ARCHITECT'S SUPPLEMENTAL INSTRUCTIONS

Table with project details: PROJECT: The Irving Lofts, OWNER: OPG Irving Partners, LLC, CONTRACTOR: MCP Group, Report No. Three (3), Date July 1, 2026, Architect's Proj No. 24-3479, Contract For: General Construction Mechanical, Electrical

THE IRVING LOFTS
 HISTORIC RESTORATION & REHAB APARTMENTS
 CLEBURNE, TEXAS

BUILDING B - PUBLIC DOOR SCHEDULE

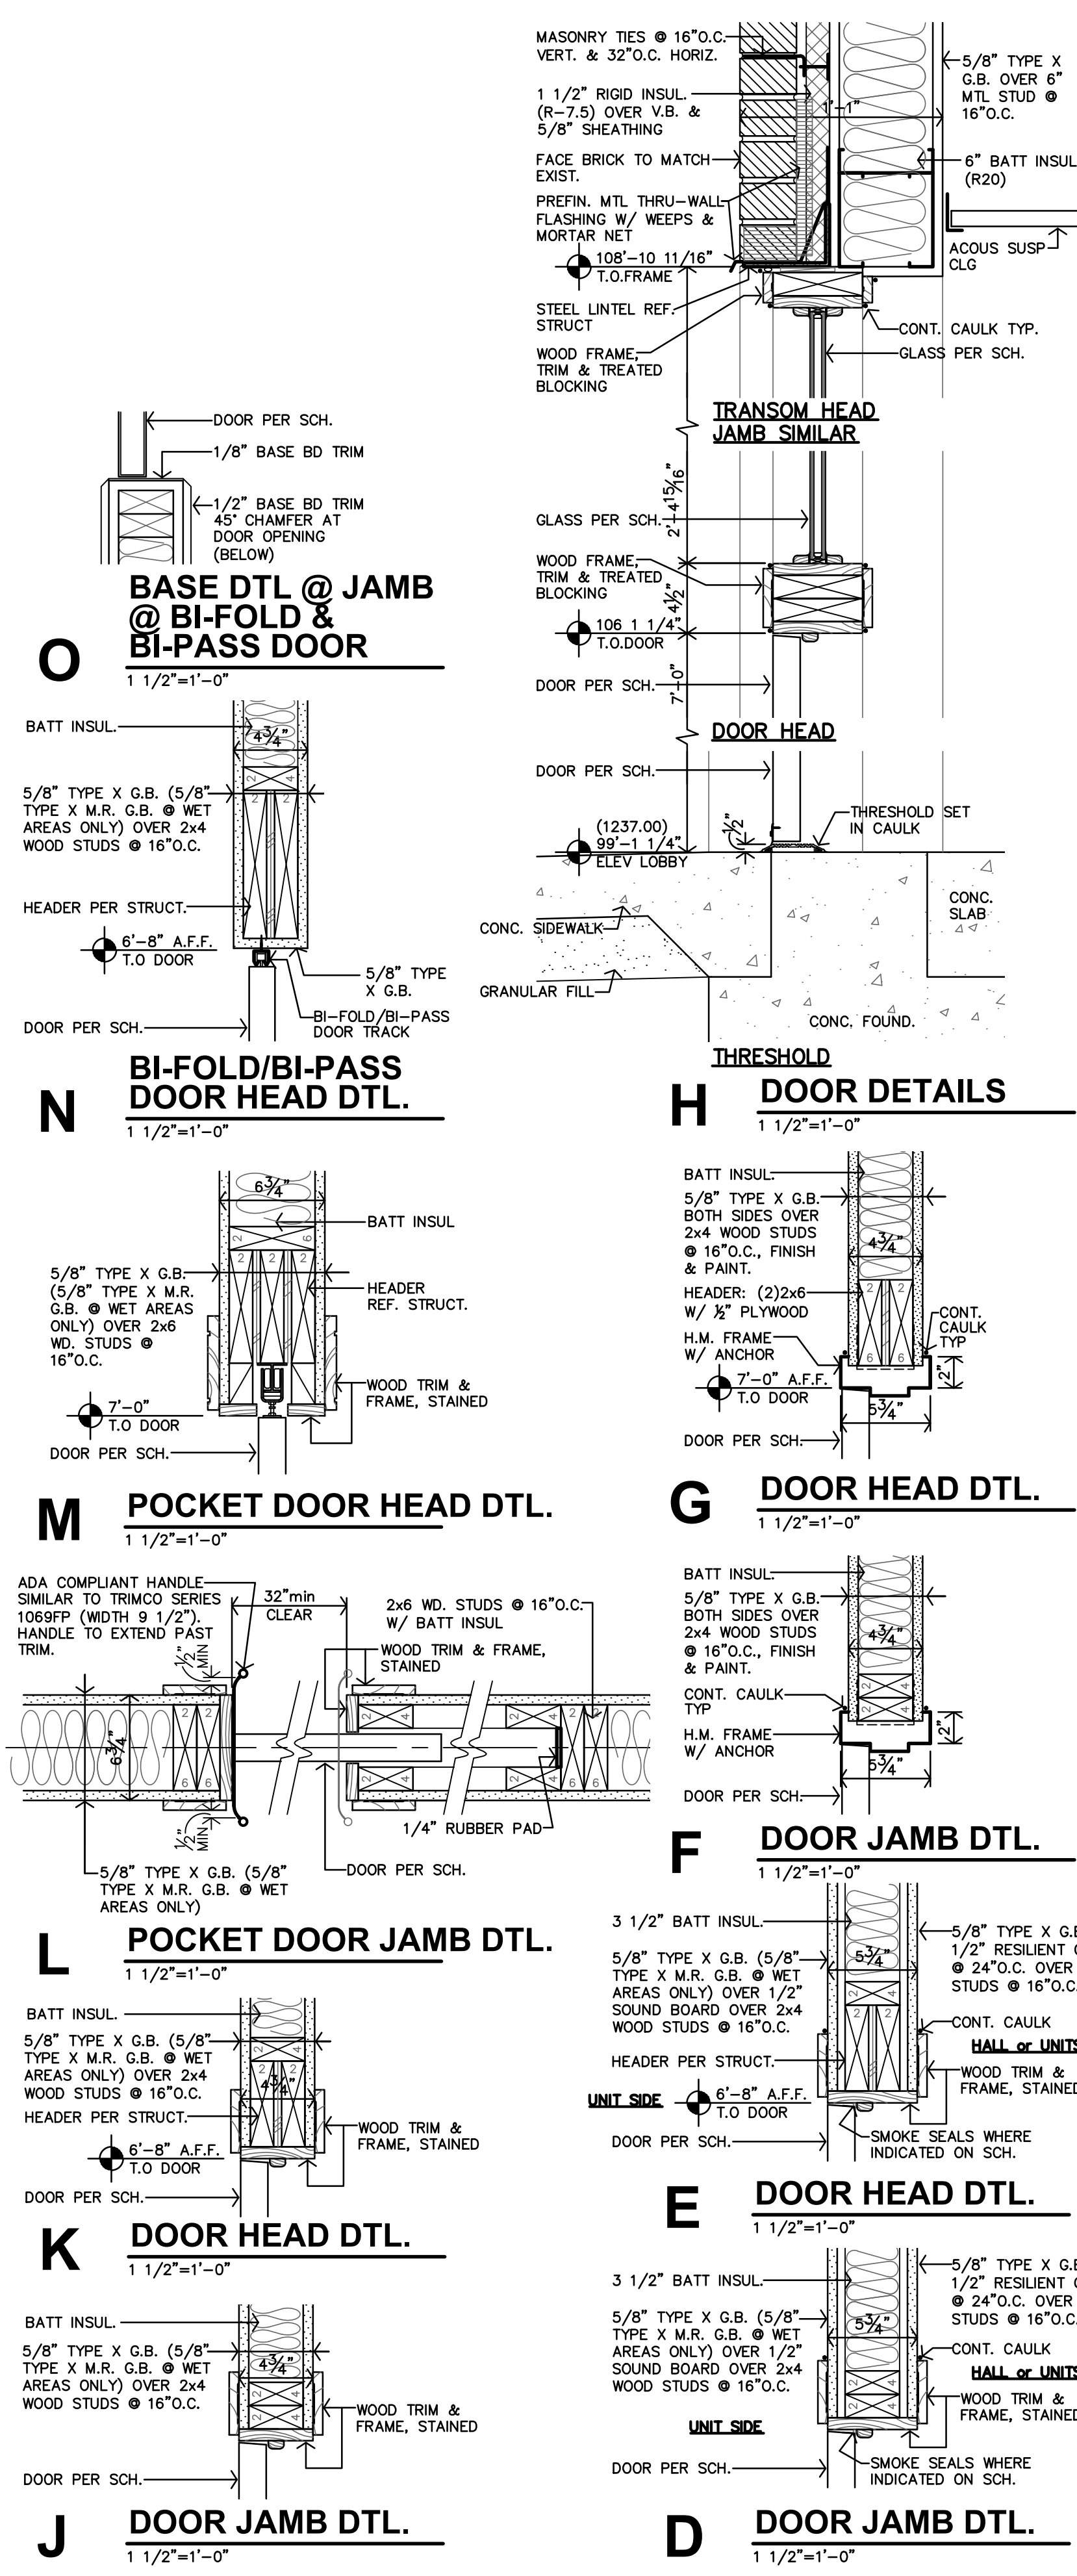
i. Doors B17, B18, B19, B20 & B23 have been adjusted to 3'-6" wide
ii. Apartment Door 4 - Mechanical has been adjusted to 3'-6" wide
iii. Apartment Door Type 6 - Laundry has been adjusted to a 3'-0" bifold door

BUILDING C
AC10.3
 COPYRIGHTED

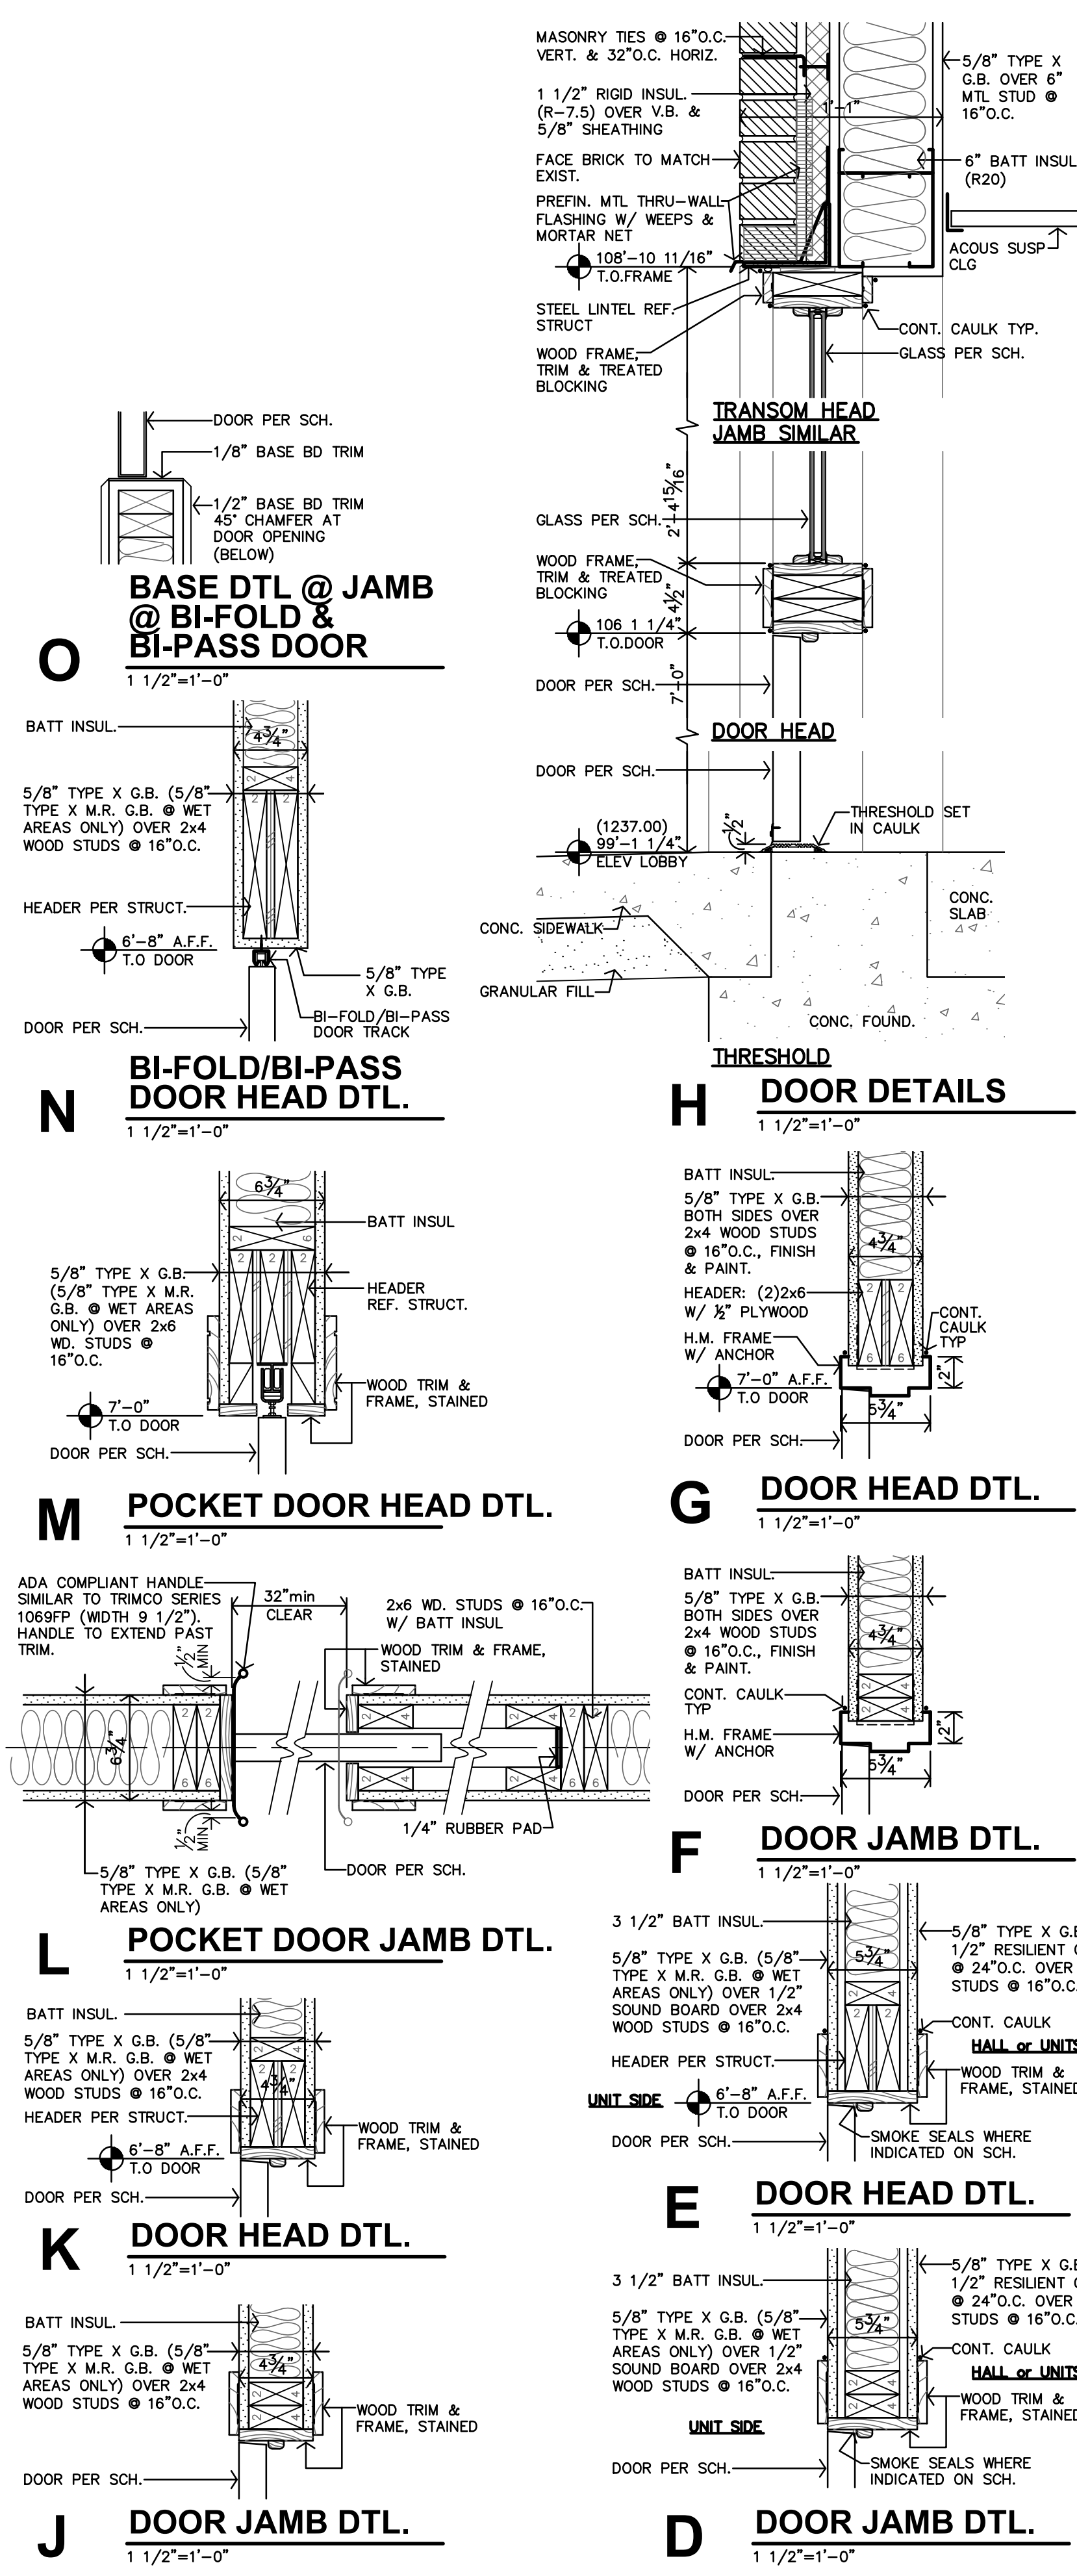
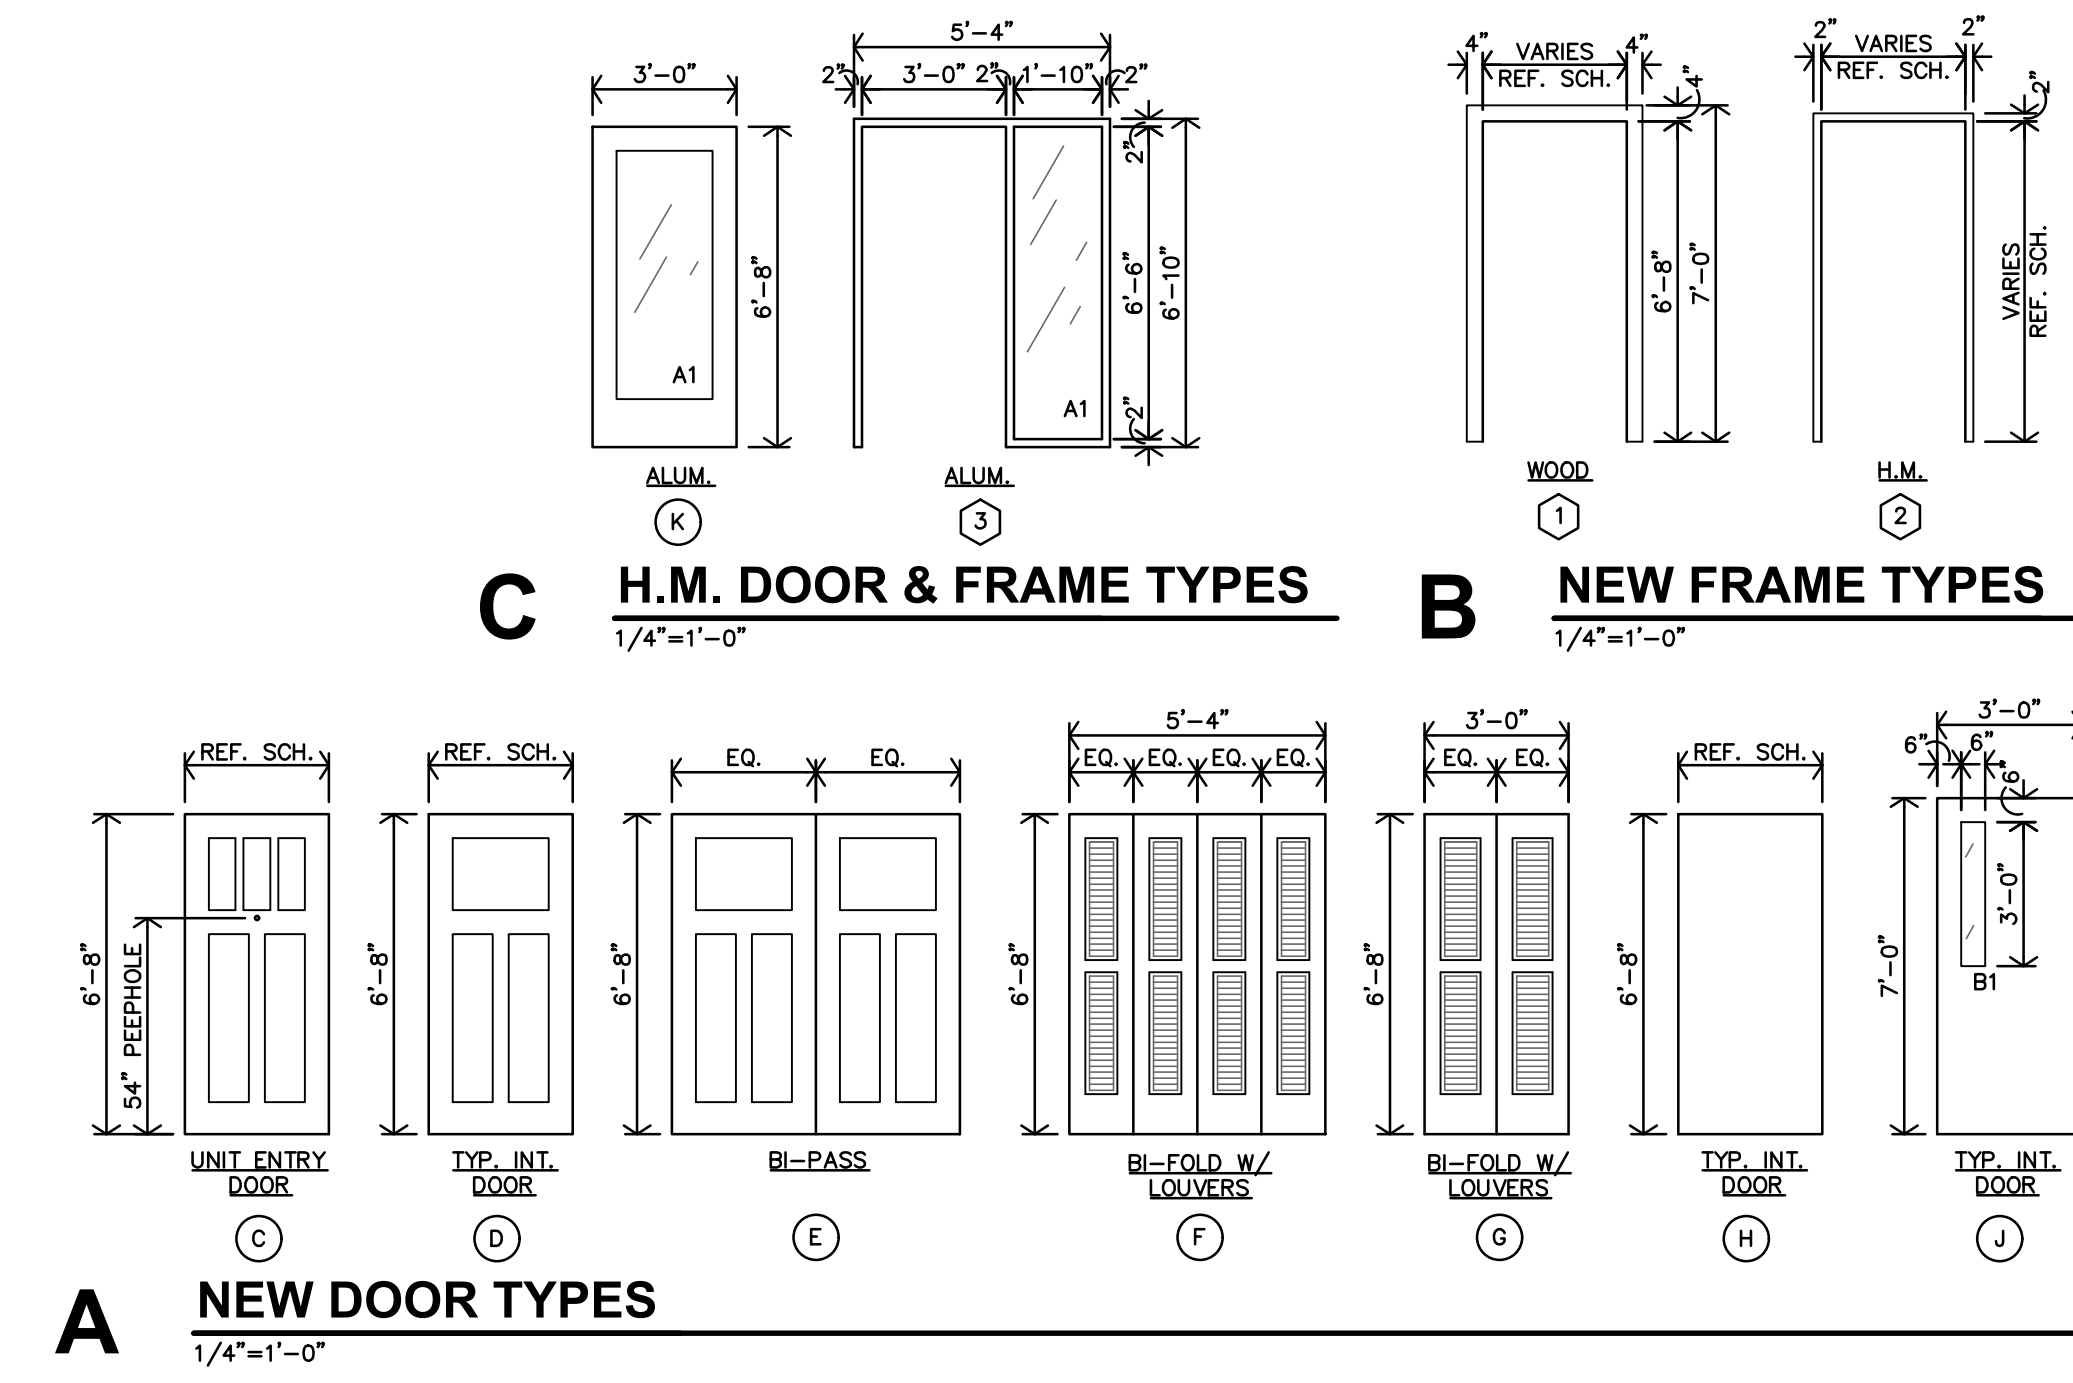
g. Sheet AC10.3
i. Doors C18 & C21 have been adjusted to 3'-6" wide
ii. Apartment Door 4 - Mechanical has been adjusted to 3'-6" wide
iii. Apartment Door Type 6 - Laundry has been adjusted to a 3'-0" bifold door
